COLLISION REPAIR INFORMATION

TITLE: QUARTER PANEL SECTIONING
(CUT-P) PROCEDURE

SECTION: EXTERIOR BULLETIN #85

MODELS: ALL TOYOTA /LEXUS

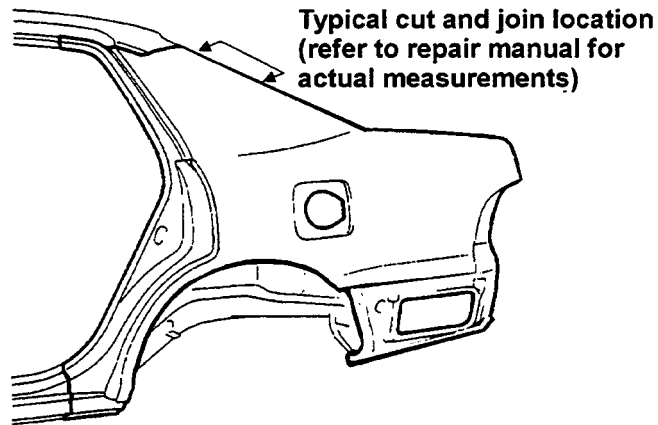
The Quarter Panel Sectioning (CUT-P) procedure, as shown in Toyota and Lexus Body Collision Damage Repair Manuals, and sometimes referred to as “vertical cut” is **no longer an approved** repair procedure (when replacing a damaged quarter panel) of any Toyota or Lexus vehicle. (see illustration below)

Toyota no longer approves of this CUT-P procedure for some of the following reasons:

- Visible cut and join locations from inner trunk compartment
- Body character lines are difficult to weld across
- Very difficult to perform an undetectable repair
- Customers overall cost of ownership is not reduced

Future Collision Damage Repair Manuals will not include the Quarter Panel (CUT-P) procedure.

The appropriate removal and installation specification for Quarter Panel sectioning are illustrated in each model-specific Repair Manual for Collision Damage, Body Panel Replacement section-Quarter Panel (CUT) procedure. The graphic below illustrates the typical cut and join location.

Always refer to the Toyota/Lexus model-specific repair manual for the actual cut/join location measurements, welding requirements and other important information.
